MODIFICATION

for C521/C541 ,C520/C540 , C522/C524

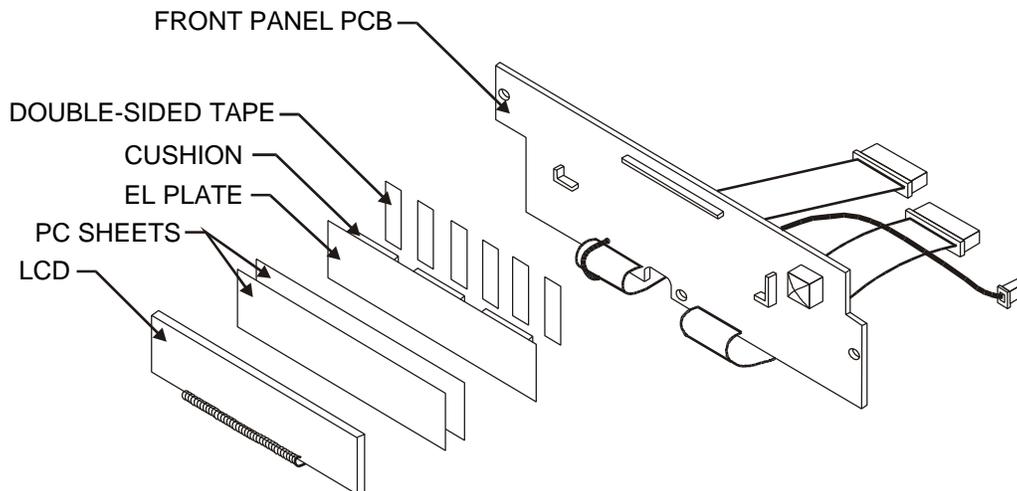
You may receive a complaint of the unit producing a very high whistle noise

The step up transformer for the display circuit is humming

1. Insert a transformer with more varnish impregnation
2. Apply glue to fix the step-up transformer to the main pcb
3. Add double sided tape between the cushion at the back of the EL display and the front panel pcb.
Please refer to the drawing below
